Arlington Conservation Commission

Date: Thursday, September 21, 2023

Agenda

FOUNDATION PLAN

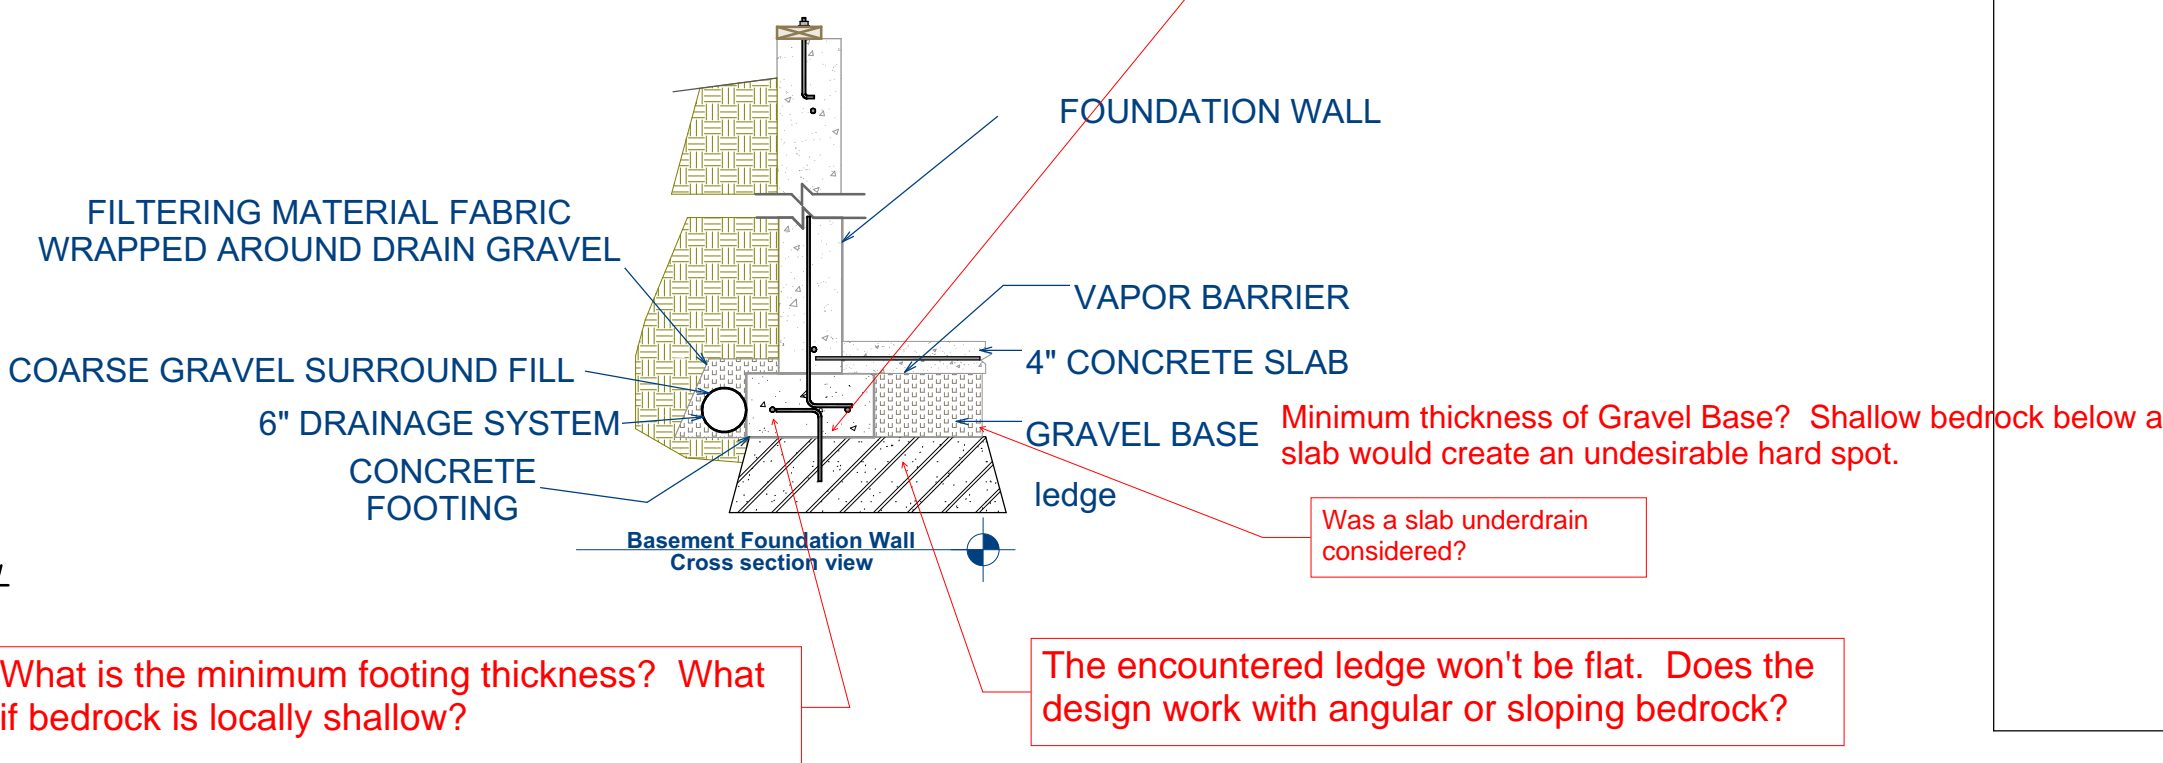
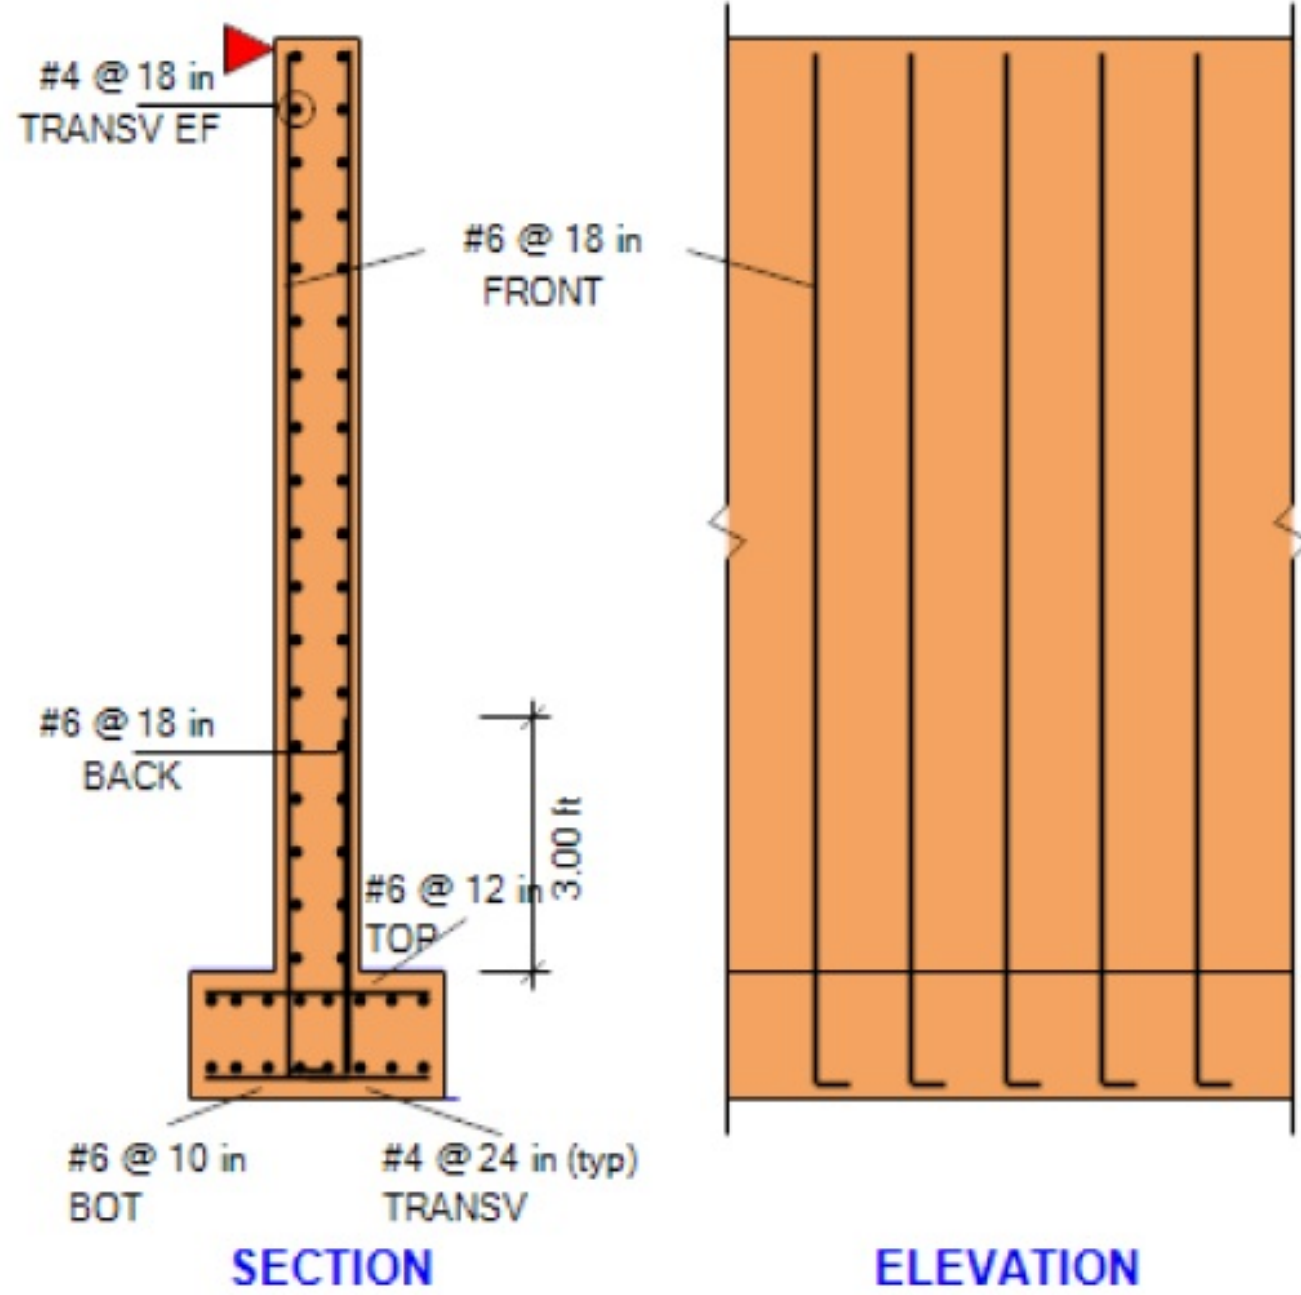
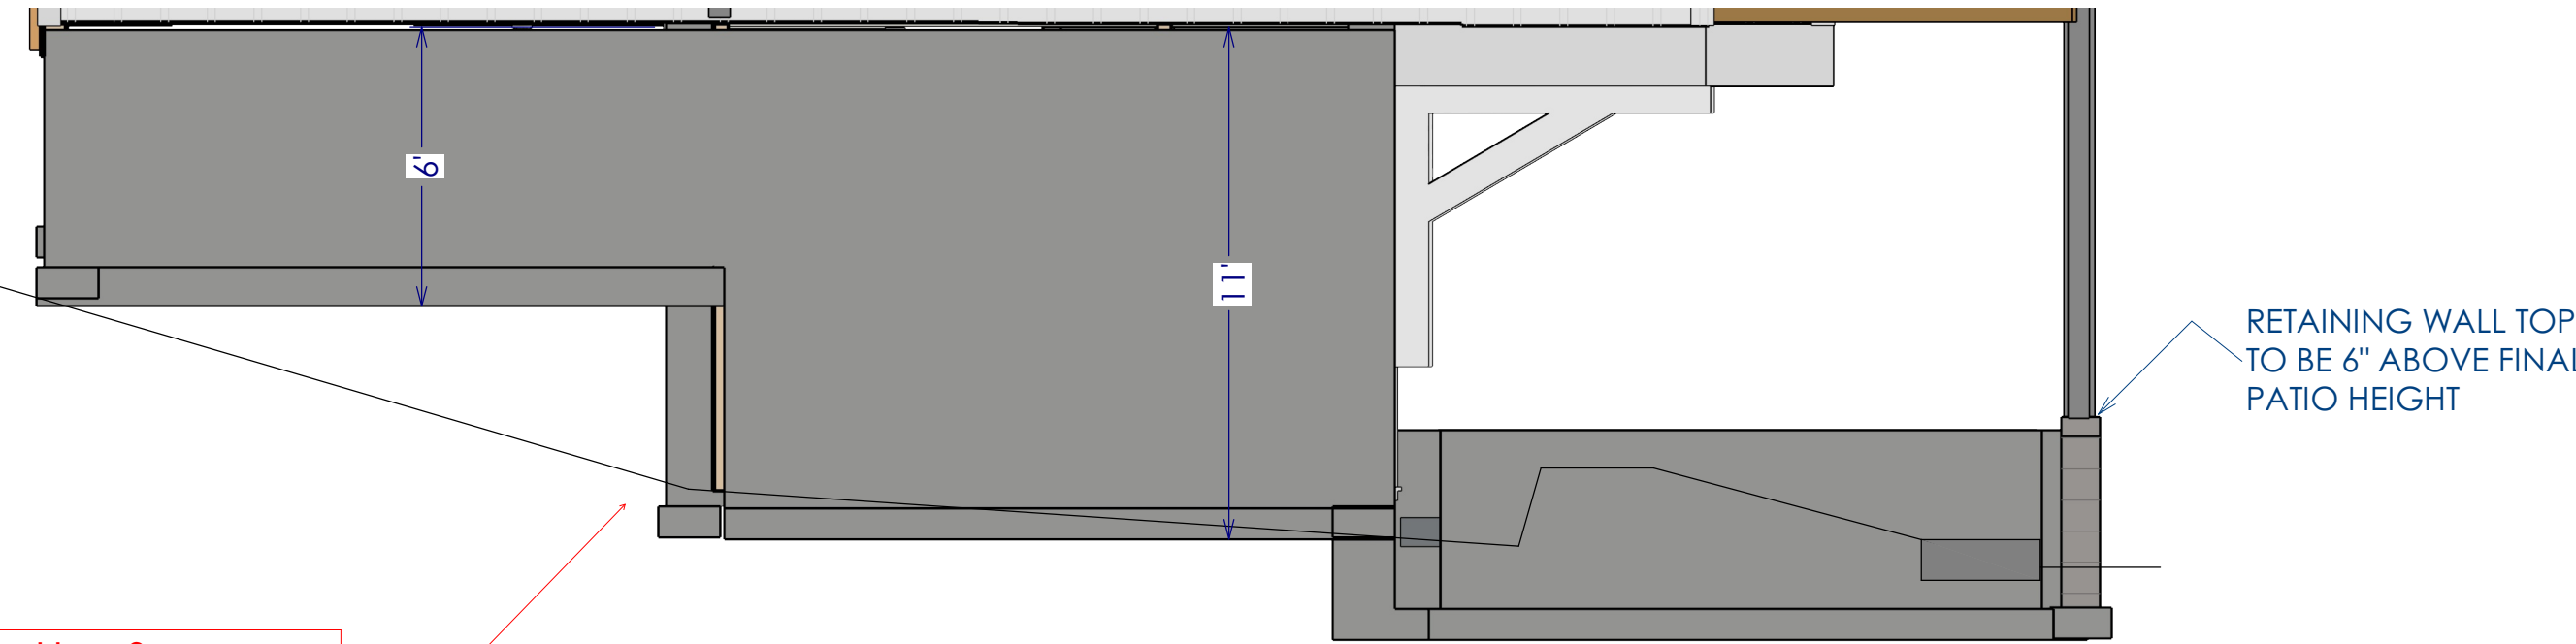
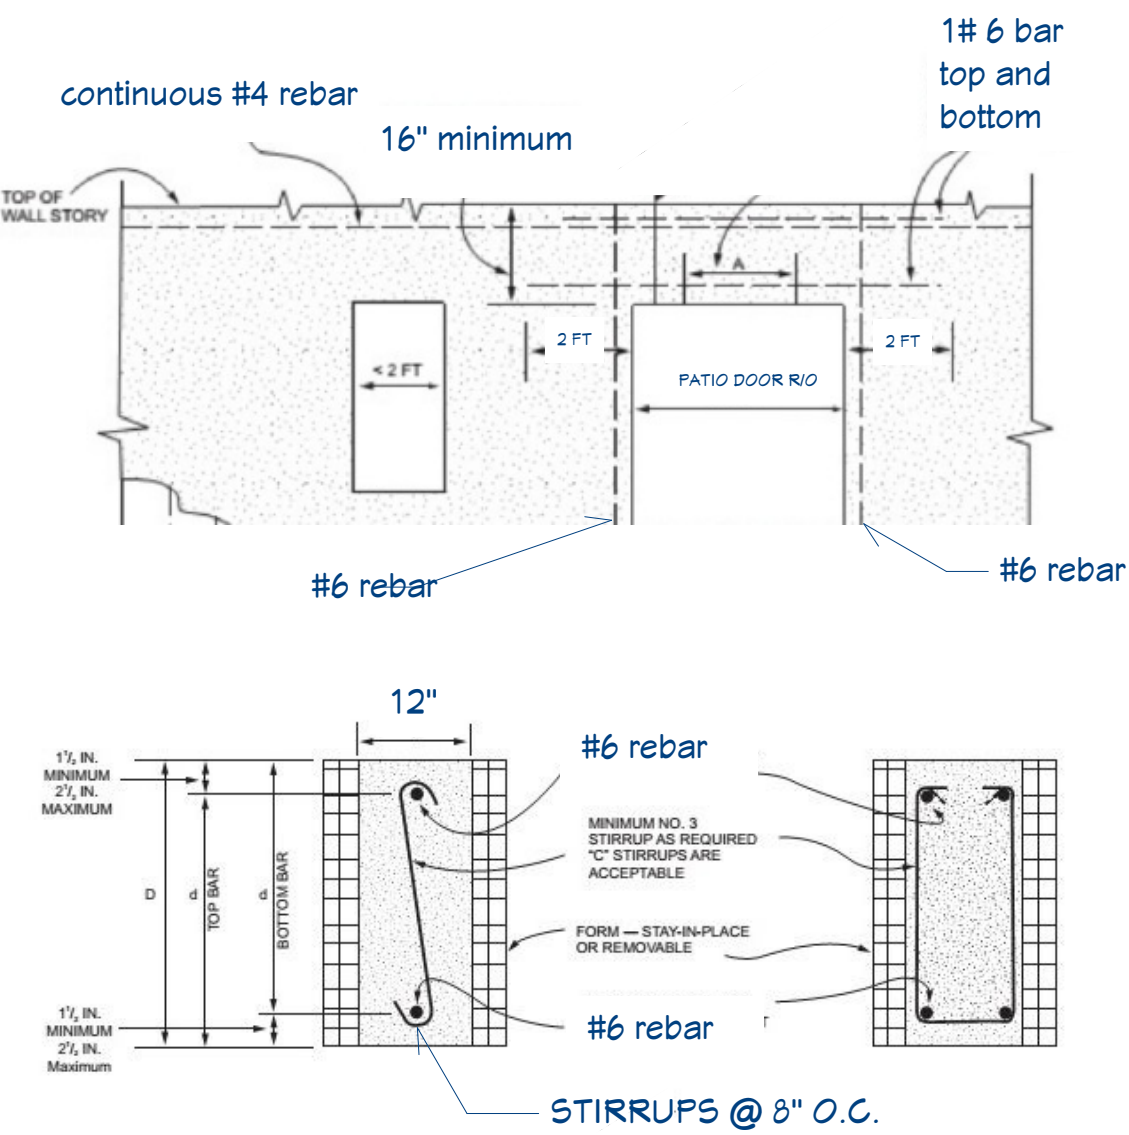
Question 2: Regarding the Foundation Plan by C. Smutzer, P.E., dated 1/13/23, the notes in the center of the drawing state that the foundation is “assumed to rest entirely on bedrock.” The top surface of the bedrock at the site is known to be very irregular. This means that significant bedrock removal would be needed to accomplish this. Do you agree with this conclusion?

Nobis Note: *Nobis’ July 24, 2017 letter report to the Town of Arlington noted (pg 4 & pg 11) that six test holes at the site reached “refusal” at depths ranging from 30 to 63 inches. The Nobis report further noted that “refusal” does not necessarily mean that the top of bedrock was reached (could be deeper). Nobis concluded, at that time, that “a degree of uncertainty in the configuration of the bedrock surface is still present.” Nobis now recommends that the Town ask the following questions:*

1. *Have there been any alterations to the top of the bedrock surface since 2017?*
2. *Is there any new information (borings, test pits, other observations) regarding the three-dimensional configuration of the bedrock surface, acquired since 2017?*
3. *Based on answers to these two questions, does the Applicant believe that a foundation can be poured on the irregular bedrock at 88 Coolidge, as the bedrock surface is currently configured and characterized?*

Question 3: Regarding the same drawing, AAT mention “cleaning” of bedrock but not removal. Is the foundation resting entirely on bedrock consistent with what is proposed by AAT? What risks might be posed by removing significant amounts of bedrock; might this cause groundwater upwelling?

Nobis Note: *Nobis suggests that the Town ask the following questions:*

4. *Can the Applicant confirm, considering the answer to the questions above, that no more intact/competent rock will be removed?*
5. *Has the Applicant made observations after large rain or snowmelt events that confirm that no upwelling of water occurs at the site under current conditions?*

6. *Is support of excavation (e.g. sheet piling) anticipated to excavate to top of competent bedrock?*

7. *Based on the Foundation Plans, dated 1/13/2023, Gravel Base is required below the proposed concrete slab. What is the minimum thickness of Gravel Base below the slab? If bedrock is locally shallow in the area of the slab, what is the plan for removal of bedrock?*

Based on the Foundation Plan, dated 1/13/2023, the foundation is assumed to rest entirely on bedrock. The above response appears to indicate that portions of the footing can be placed over engineered fill. Confirm if portions of the footing can be placed over engineered fill. Typically, placing a portion of a footing on bedrock and a portion over fill has the potential to result in undesirable differential settlement.
